**Subject: Response to RW Gillespie & Associates Review of Gilman St. Temporary Support of Excavation Design Letter dated 1/21/21**

Subject: Geotechnical Engineering Review of Gilman Street Temporary Support of  
Excavation Design  
Maine Medical Center Hospital Expansion  
Portland, Maine  
RWG&A Project No. 0557-031

## SECTION AT GILMAN ST LOOKING SOUTH TIEBACK 9 & 10

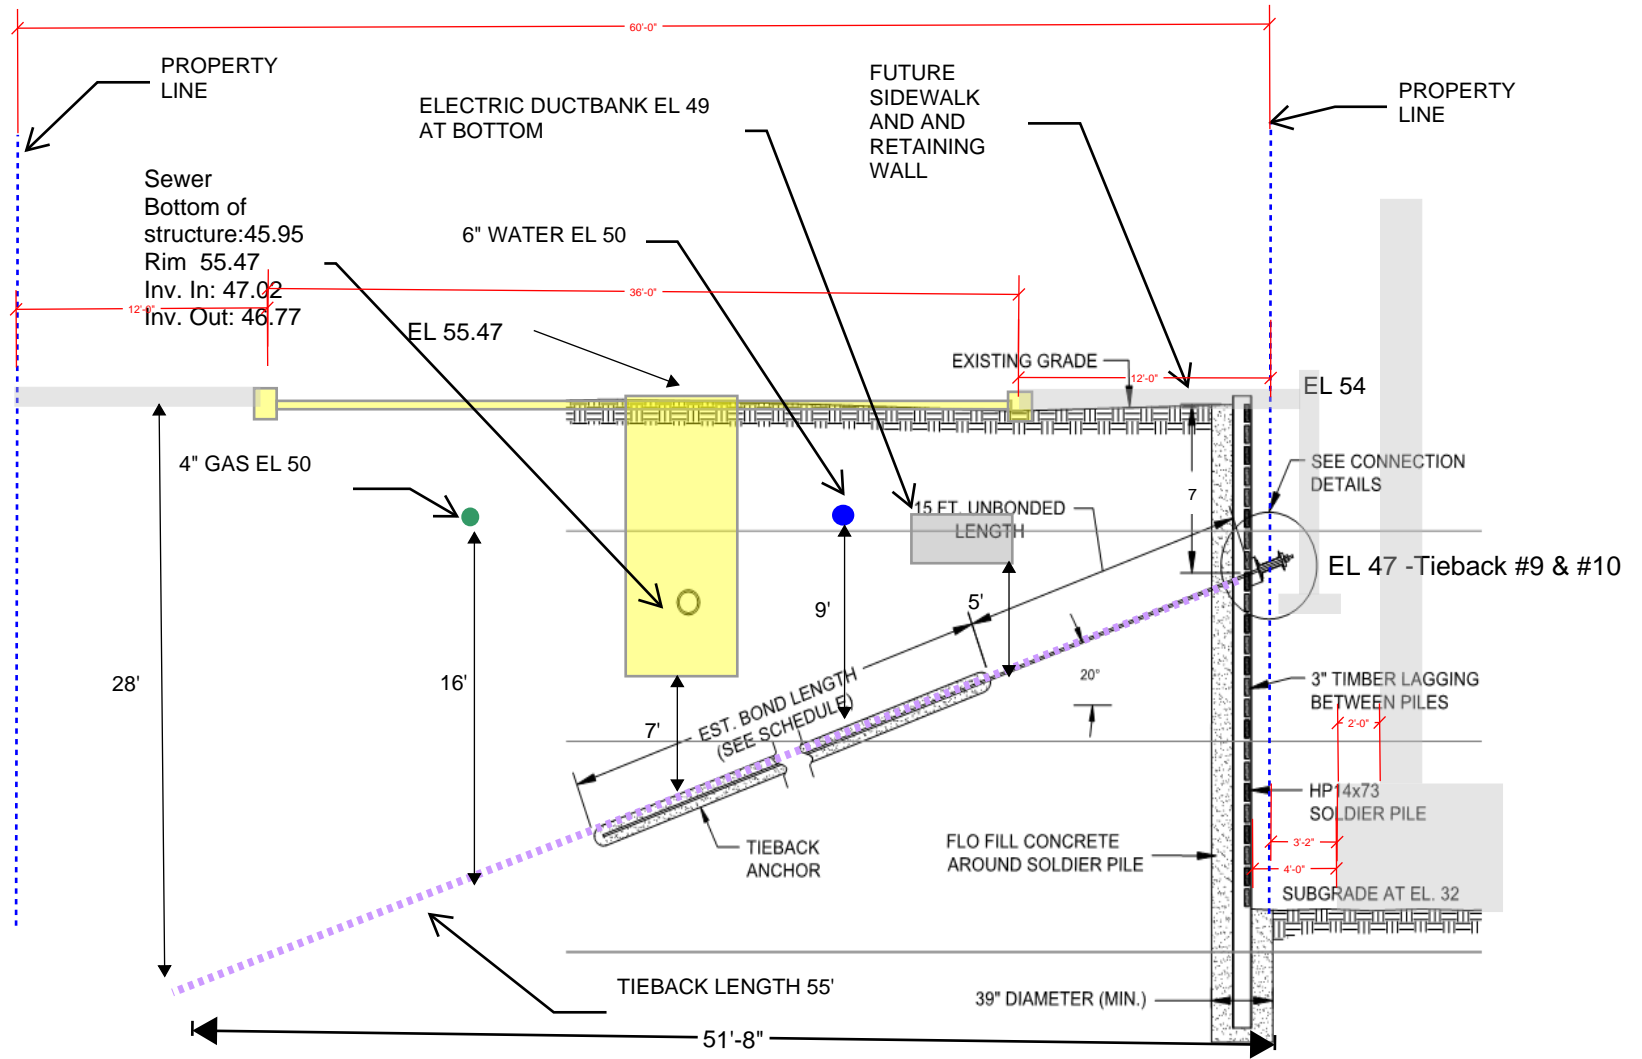
Based on the enclosed sketch titled *Section at Gilman St. Looking South Look South, Tieback 9 & 10*, the tiebacks would pass about 5 feet below an electrical duct bank, about 9 feet below a 6-inch waterline, about 5 to 7 feet below the bottom of SMH-8 and SMH-13533, and about 16 feet below a 4-inch natural gas pipeline at the west side of Gilman Street. The Contractor proposes to abandon four grouted soil tiebacks and four steel, H-shaped soldier piles in-place after the excavation between the SOE system and building foundation walls is backfilled. The H-piles are about 24 inches square in plan dimensions and would be surrounded by "flo fill" which we understand is a low-strength concrete. The sketch indicates that the "flo fill" and soldier piles would be removed to a depth 6 feet below the final grade after completion of foundation work.

Anchor Tieback Limits: The sketch prepared by Turner indicates that the Gilman Street right-of-way is 60 feet wide. The design calls tieback 65 feet long installed at a 20-degree downward angle. Based on the length and angle, the tiebacks would extend a horizontal distance of about 61 feet. It appears from the wale-to-pile connection detail that about 1 foot of the tieback would be located on the project side of the boundary, which would locate the end of the tieback very close to the Gilman Street westerly right-of-way boundary. If there are deviations from the design tieback lengths and inclinations, or in soldier pile positions, it is conceivable that the tieback might extend outside of the right-of-way and into the abutter's property.

*MMC should affirm that survey, construction, and design modifications are in place to assure that the tieback system will not extend beyond the westerly right-of-way boundary. The contractor should indicate how location, length, and angle control will be maintained and verified during installation.*

**Response:** Keller - We will fabricate the tiebacks on site to the exact lengths as show in the design submittal drawings. The verticality / batter angle of the drill hole will be monitored by the use of a digital angle gauge which has a + - 0.2 degree angle accuracy which will be attached to the mast of the drill rig.
